Alton Coal Development, LLC

Subject: **Evaluation of Pipeline from Pit 10 to Sediment Pond 3, Pond 1 and facility waterline revisions, Alton Coal Development, LLC, Coal Hollow Mine, Kane County, Utah, C/025/0005, Task 4951**

Title: Evaluation of Pipeline from Pit 10 to Sediment Pond 3, Pond 1 and Facility Waterline Revision

FIGURE 1

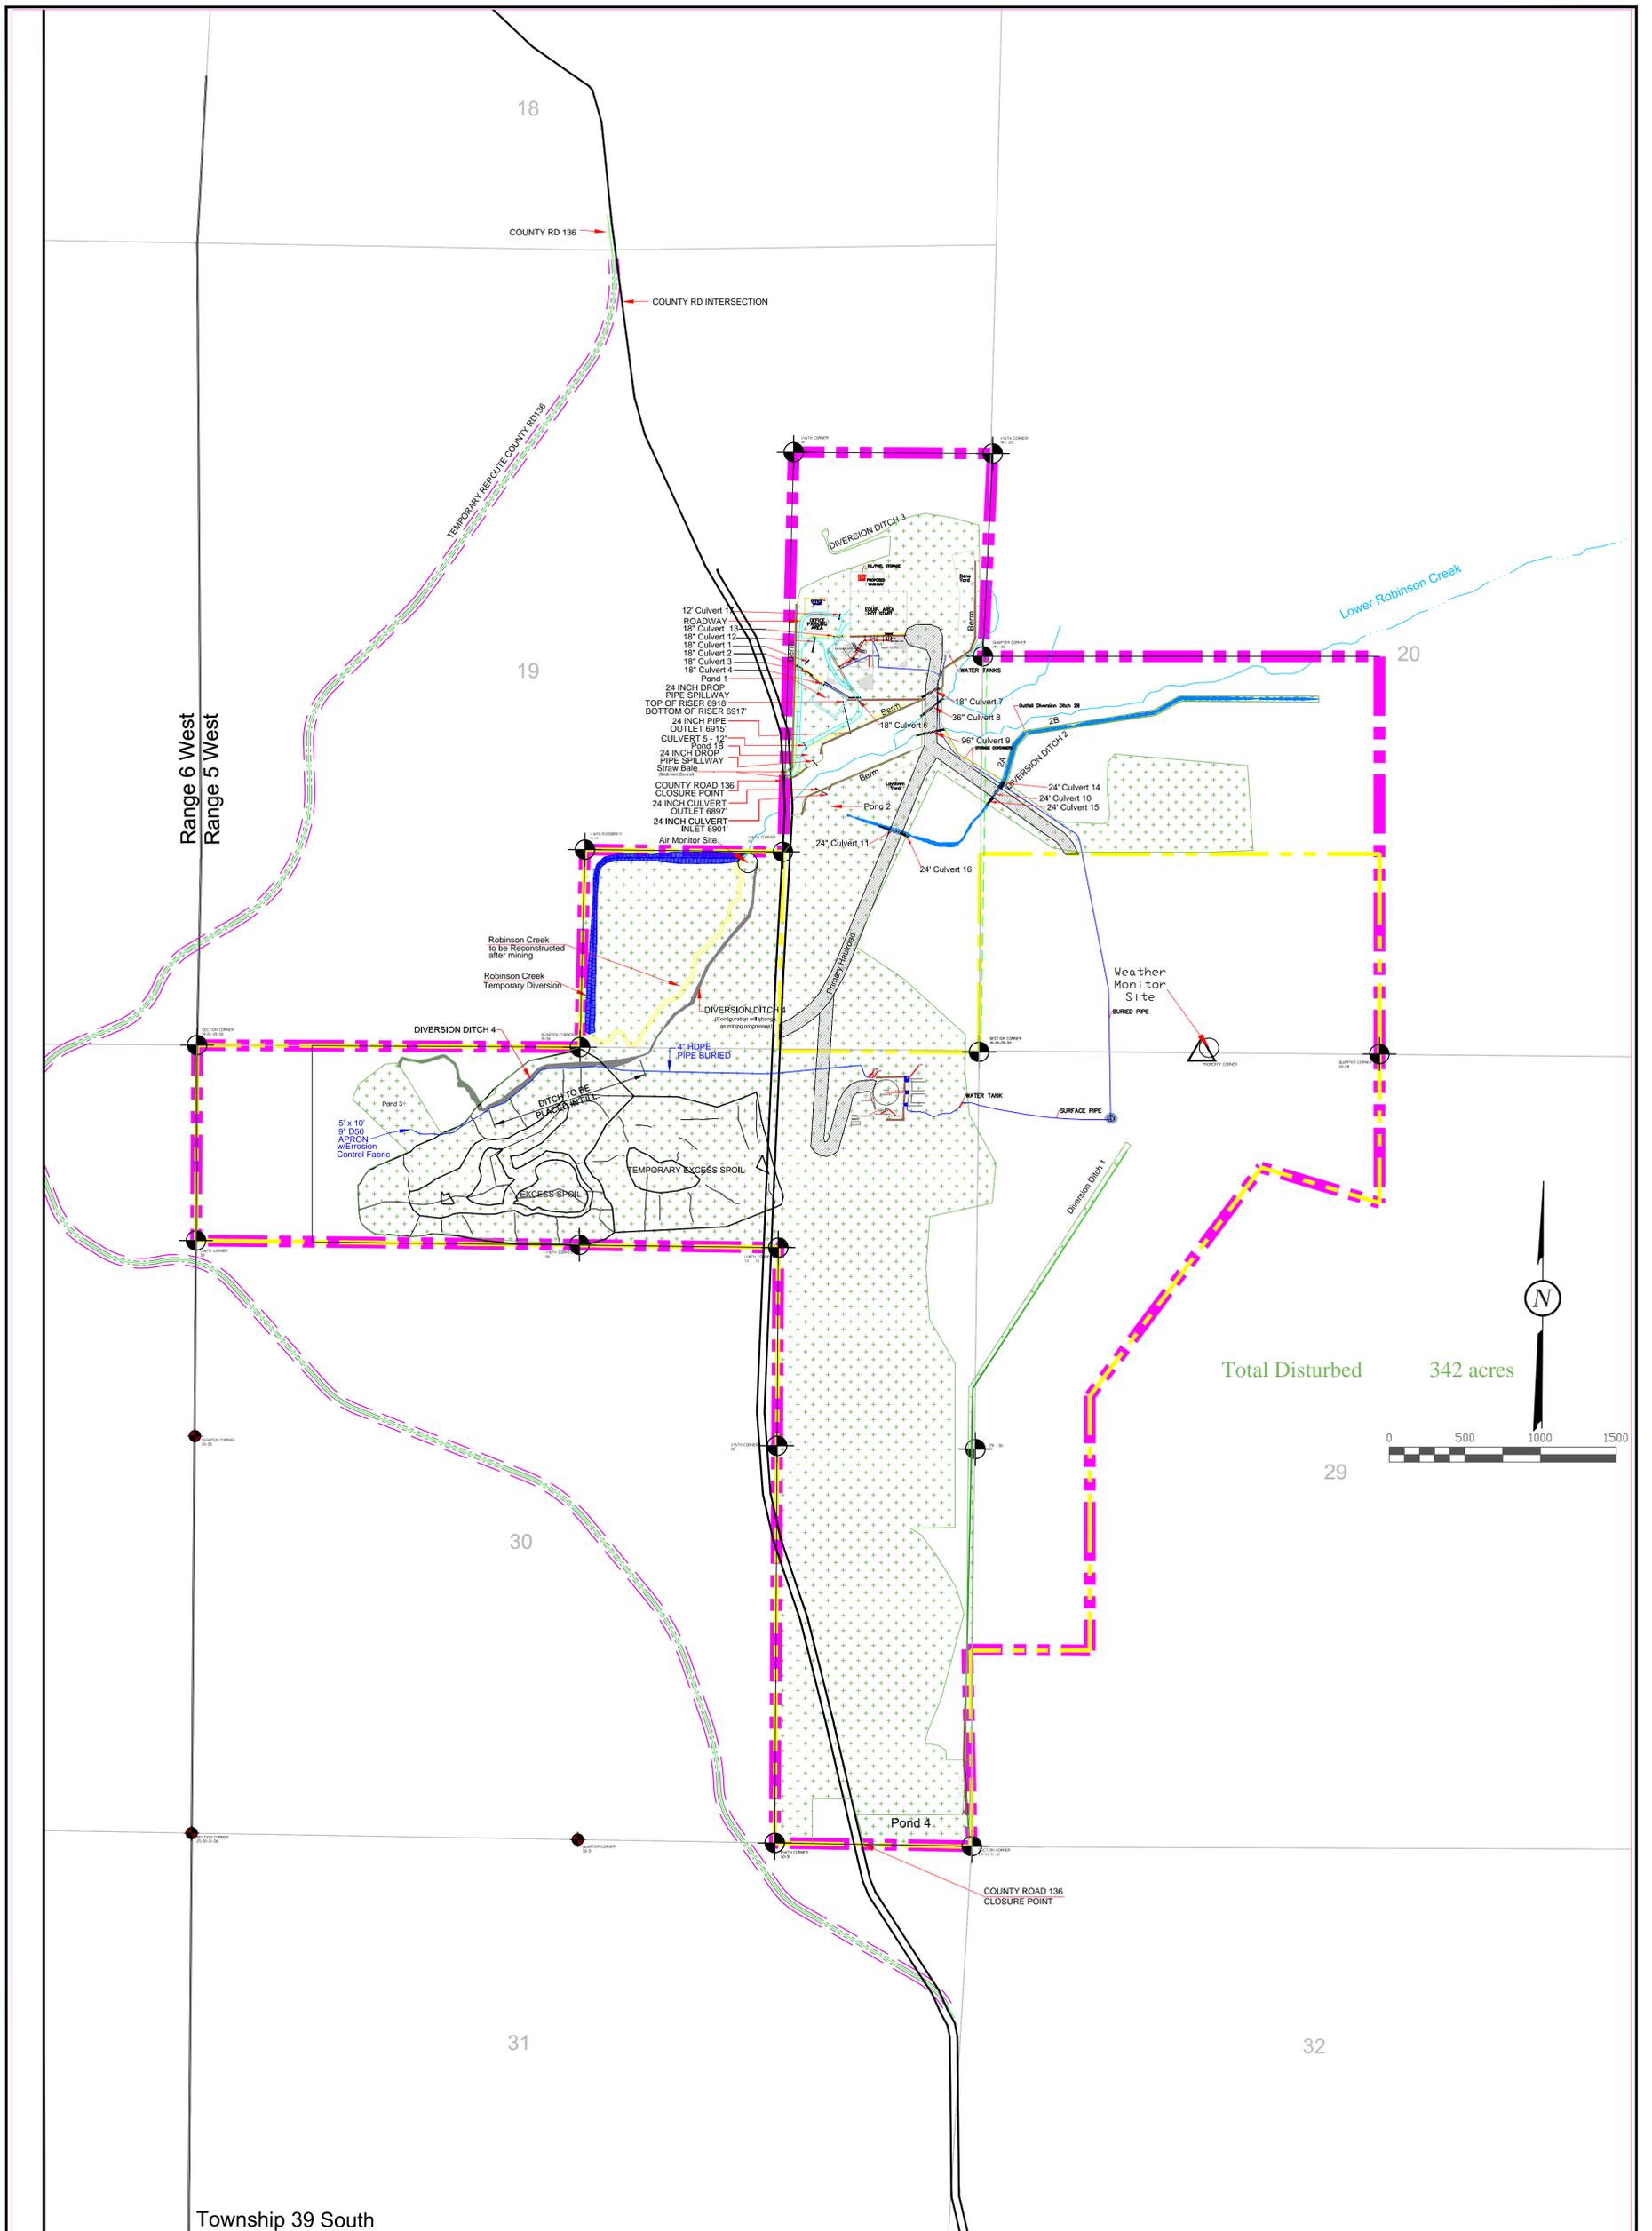
R645-301-733. The application needs to provide engineered drawings of the water impoundment structure in the base of Pit 10.

Figure 1 of Appendix 5-13 has been revised to show details of the Pit 10 Sump.

SEDIMENT IMPOUNDMENT POND 1 DETAILS
 COAL HOLLOW PROJECT
 ALTON, UTAH
DRAWING: 5-28

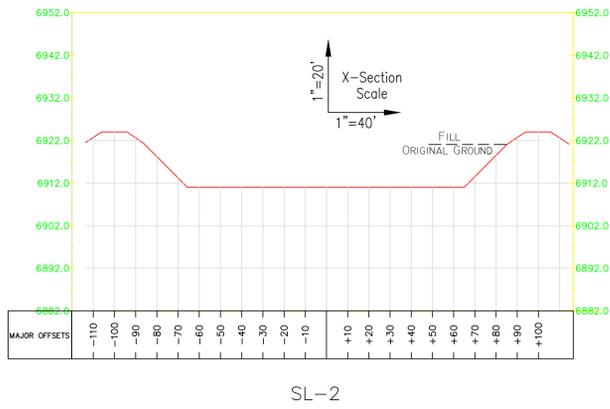
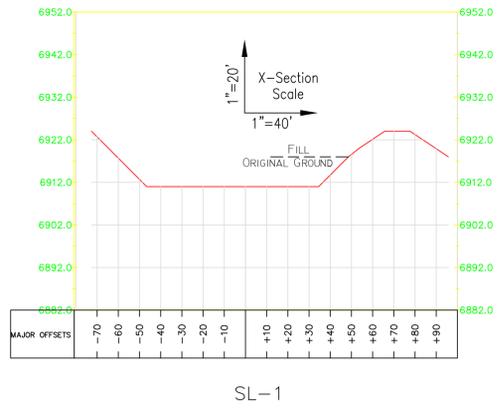
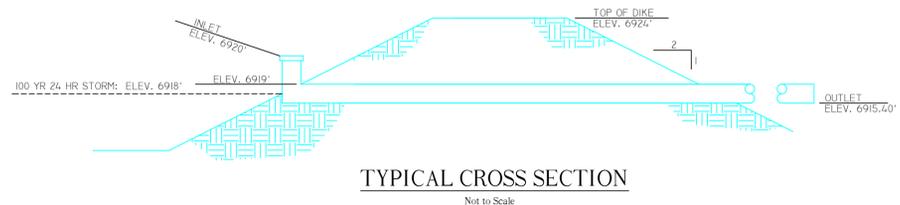
R645-301-742.220. The storage volume computations found in the Drawing 5-28 table labeled 'Sediment Impoundment Pond 1 STORAGE VOLUME COMPUTATIONS' are incorrect. Correct calculations of the storage size of Pond 1 are needed.

Drawing 5-28 has been revised to more accurately depict Pond 1 as well as correct the storage volumes presented in the table.

DRAWING: 5-30

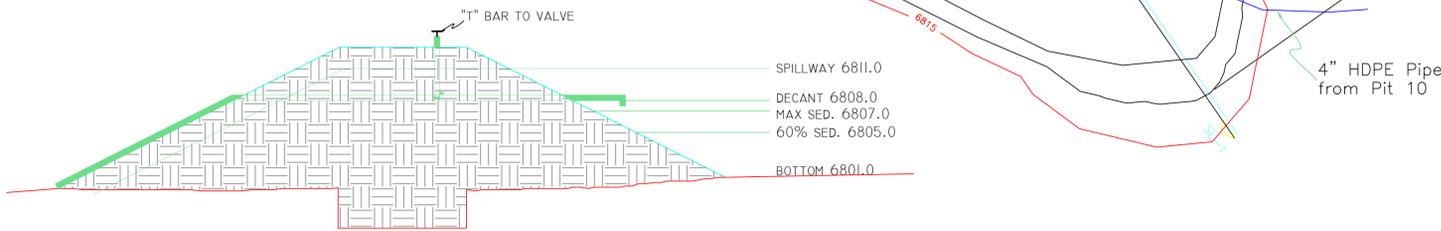
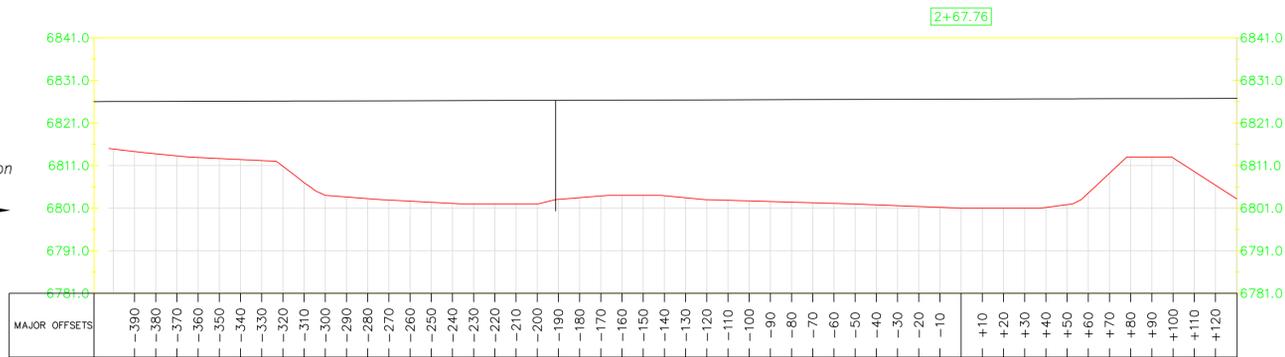
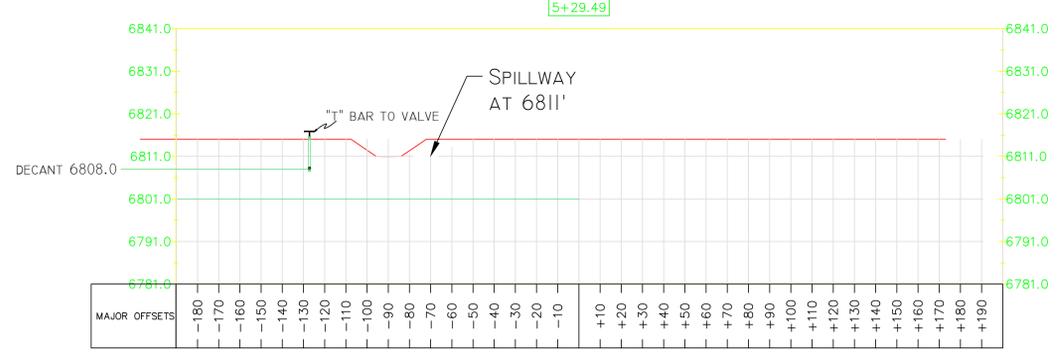
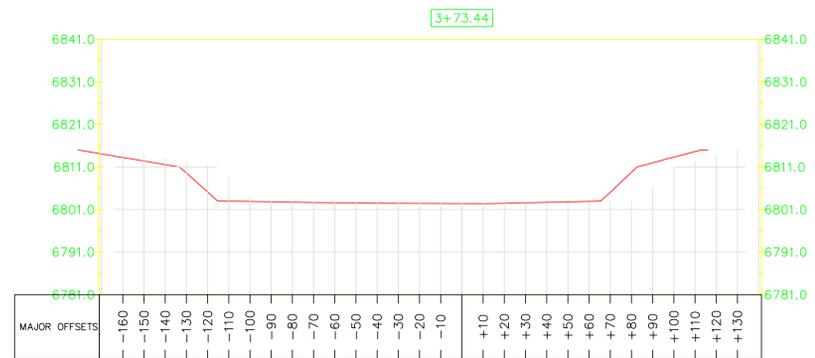
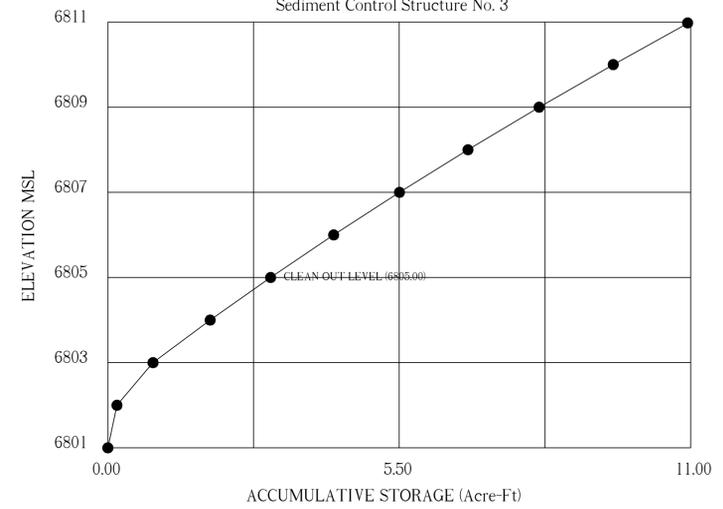
R645-301-746.221: A non-erosive apron is necessary at the outlet of the mine water discharge pipe flowing into pond 3. Prior experience has shown rip-rap does not adequately stabilize and protect water conveyance structures (ditches, inlets, outlets, etc.) from eroding. Therefore, additional stabilization of the rip-rap apron is necessary. Possible stabilization designs include, but are not limited to: a gravel or fabric filter under the rip-rap or a grouted rip-rap curtain that will aid in stabilizing the extremely erosive soil base of the apron.

R645-301-743.131.1 – Sediment Pond 3's discharge spillway for the decant pipe does not meet the minimum requirements to carry sustained flows.

R645-301-733.120: Sediment Pond 3 Drawing 5-30 needs to be updated showing the mine water discharge pipe and the apron at its base, and the stabilized outlet design of the decant pipe.

Appendix 5-13 has been updated to include erosion control fabric. Drawing 5-30 has also been updated to reflect this change.

The 6" decant pipe as well as the discharge spillway from Pond 3 are of nonerodible construction. The decant pipe is constructed of PVC and discharges to the Pond 3 discharge spillway. The Pond 3 discharge spillway is constructed of 6" minimum rip-rap on a non-erosive apron of erosion control fabric. Drawing 5-30 has been updated to reflect the as-built design of the decant and discharge spillway of Pond 3.

Drawing 5-30 has also been updated to reflect these changes.
